**NSLPP MEETING HELD ON 6/12/23**

**ADDRESS:** 173-179 Walker Street, 11, 15 & 17 Hampden Street North Sydney

**APPLICATION No:** 367/22 (PAN 283364)

**PROPOSAL:** Demolition of all buildings and site preparation works, removal of two trees and relocation of a sewer line and install a new sewer connection, and diversion of stormwater infrastructure

DRAWING NAME:  
EARLY WORKS  
STORMWATER LONGSECTION

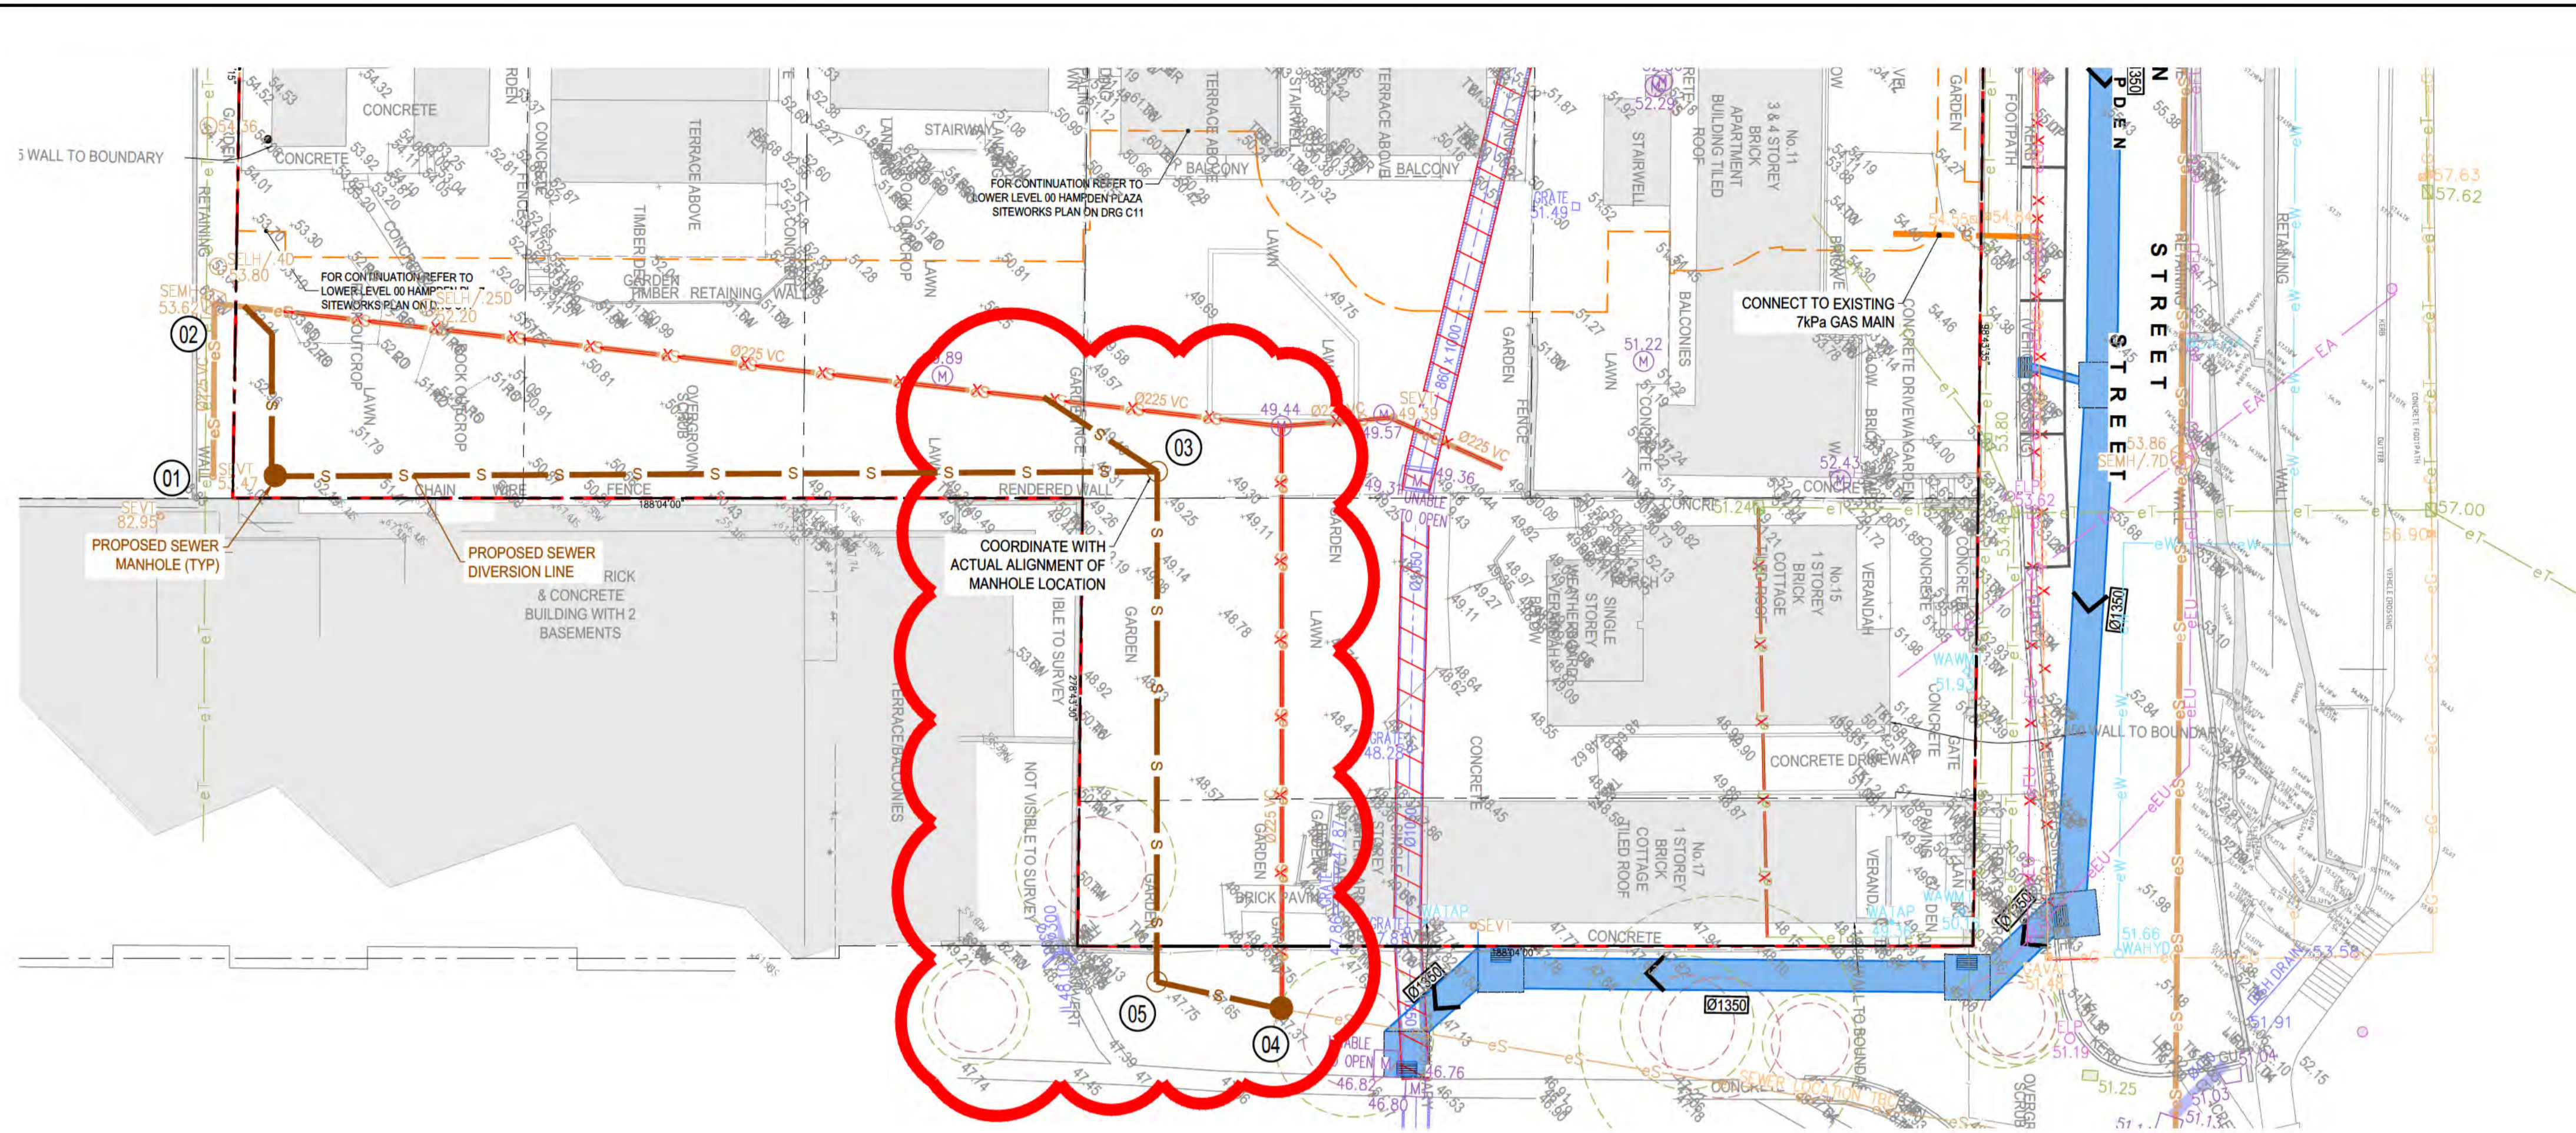
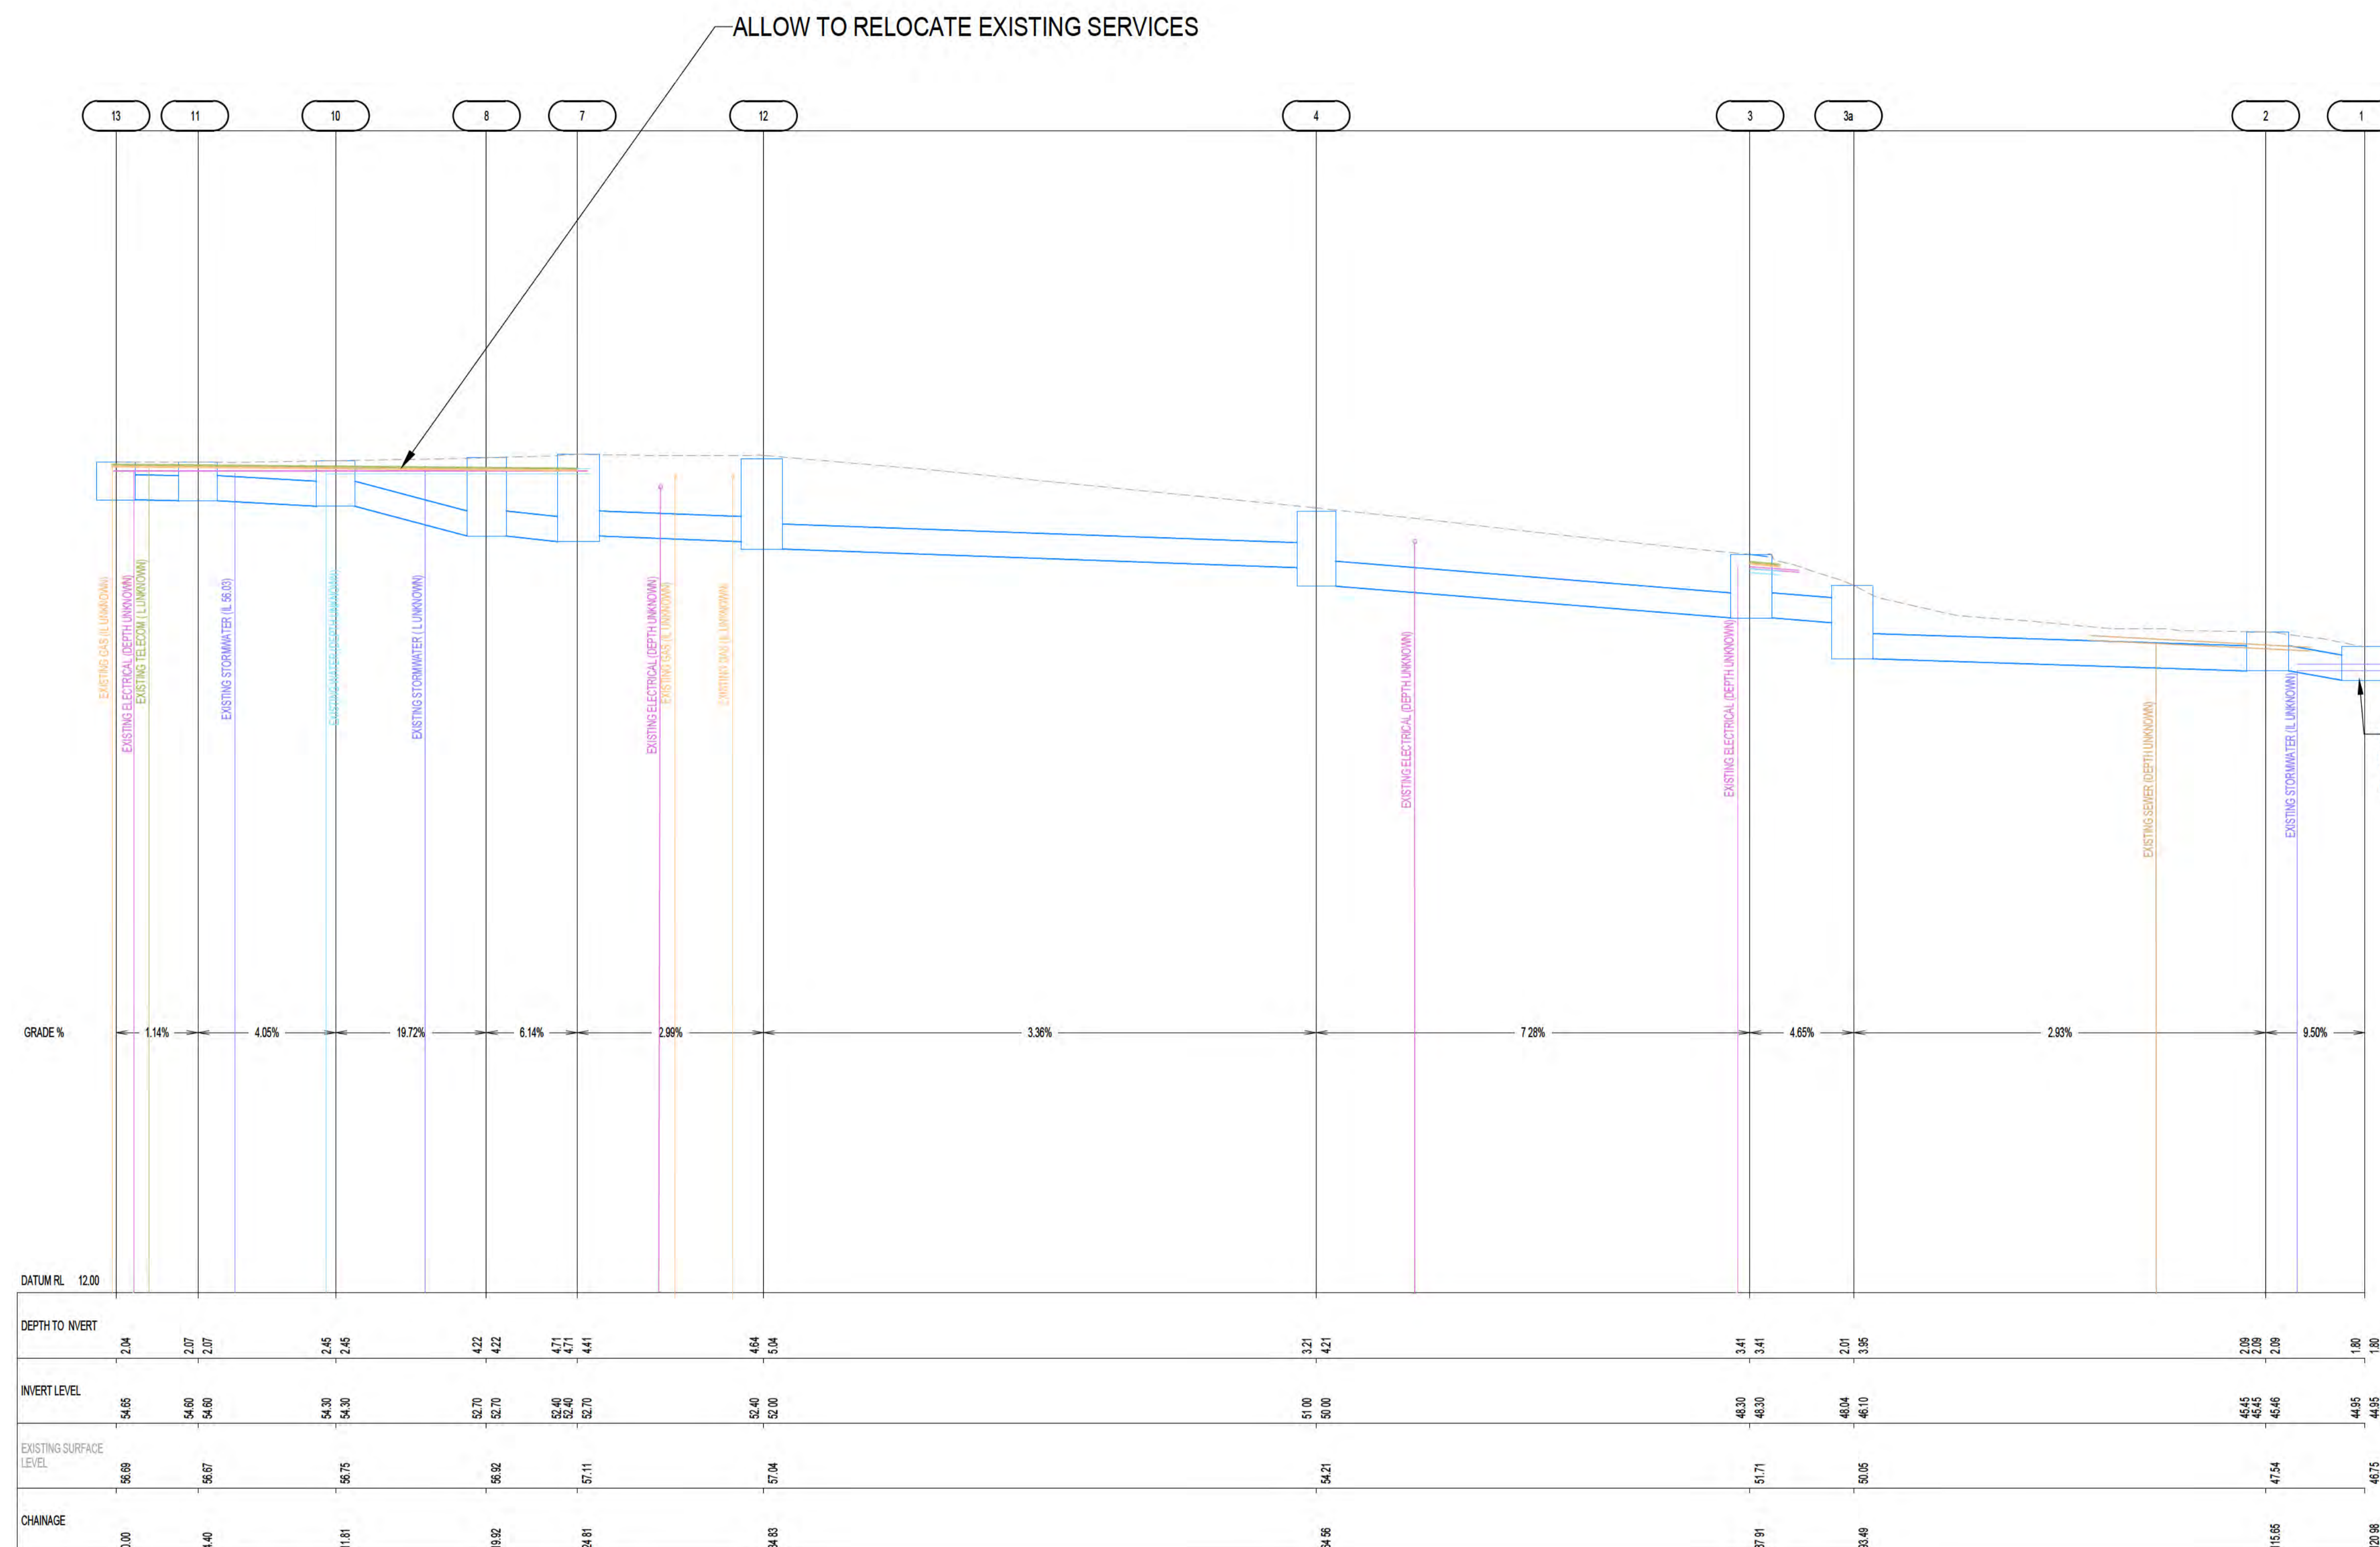
- The new drainage line should be located below new kerb & guttering, not in the middle of the road (Hampden Street).
- A hydraulic grade line is to be added to the drainage long-section to ensure that the drainage has sufficient capacity.
- The final alignment and capacity of the drainage system are to be approved.
- The existing pipe is 5m deep in some locations, pit designs provided are for max 3m deep. Revised pit designs and a pit schedule must be provided for approval.
